Dear Reviewer:

Finally, we sincerely thank you for your valuable comments and suggestions. In accordance with your recommendations, we have made major revisions to the manuscript. Your insightful and constructive feedback has greatly improved the quality of this paper. Our responses to the reviewer's comments are provided below:

Figure 6: Location of coastal computation points and schematic diagram of the RET method and mass center offset correction.

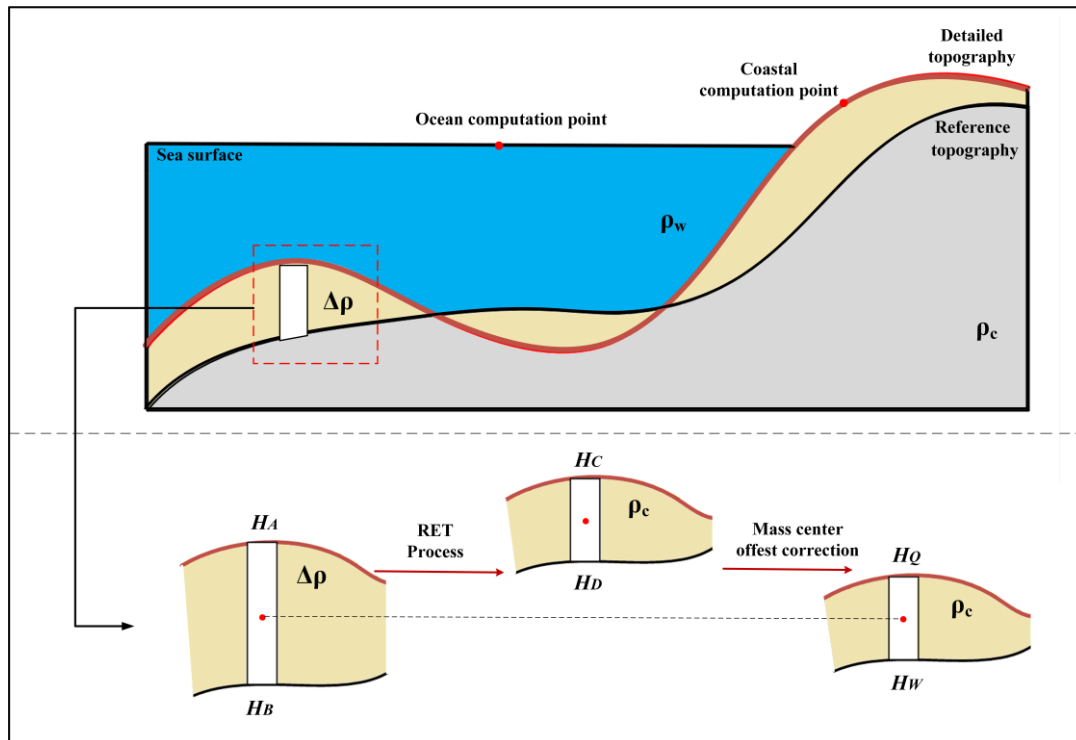
Point 2: Regarding the deletion of Figure 6 in the original manuscript.

We sincerely thank you for your valuable suggestion. Retaining and revising Figure 6 can indeed help readers better understand the RET and mass center offset correction (MCOC). In accordance with your suggestion, we have revised Figure 6 in the original manuscript accordingly.

Figure 3: Schematic diagrams of the RTM over land (a) and over the marine area (b).

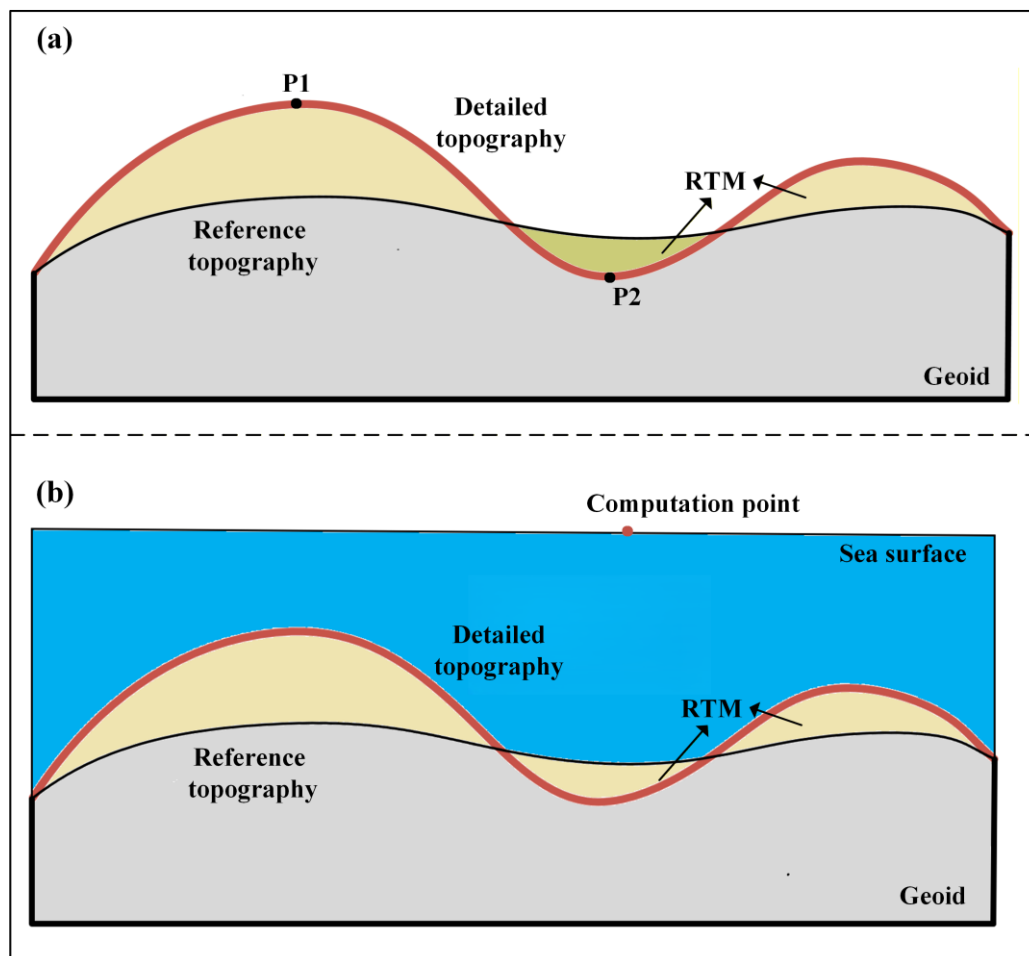
Point 7: Figure 3 only gives the example of the RTM for the land area. The one using the RET for the marine area should be added.

“The schematic diagram of the RTM for land and marine areas is shown in Figure 3, where the RTM for the marine area is obtained using the RET method.”
